AMENDMENT NO. 3 AUGUST 2006
TO
IS 4580 : 1986 SPECIFICATION FOR BRUSHES,
SHAVING
(First Revision)

Amend No. 3 to IS 4580 : 1986

FIG. 2 BRUSHES, SHAVING, GRADE 2

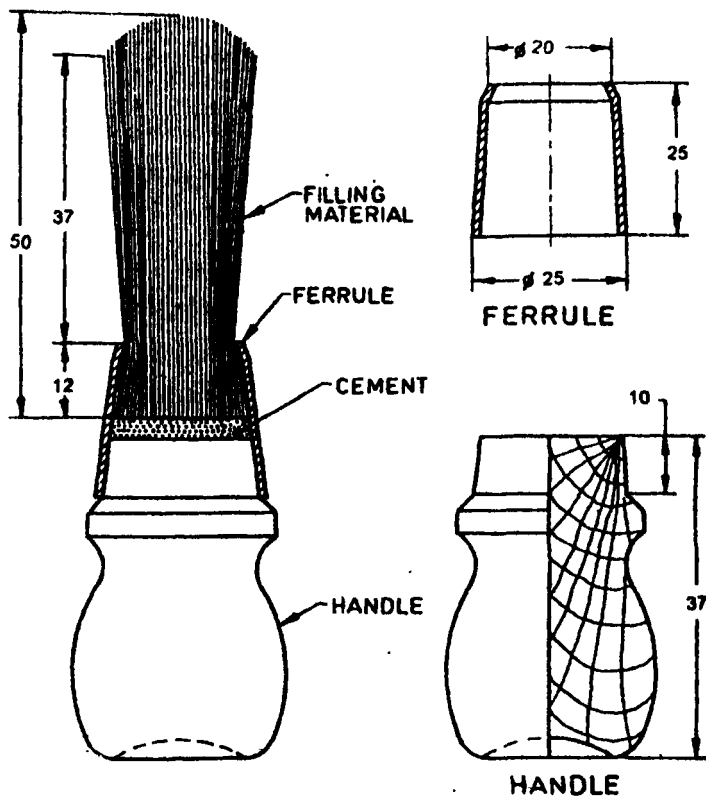
(Page 7, Fig. 2) — Substitute the figure given on page 2 for the existing.
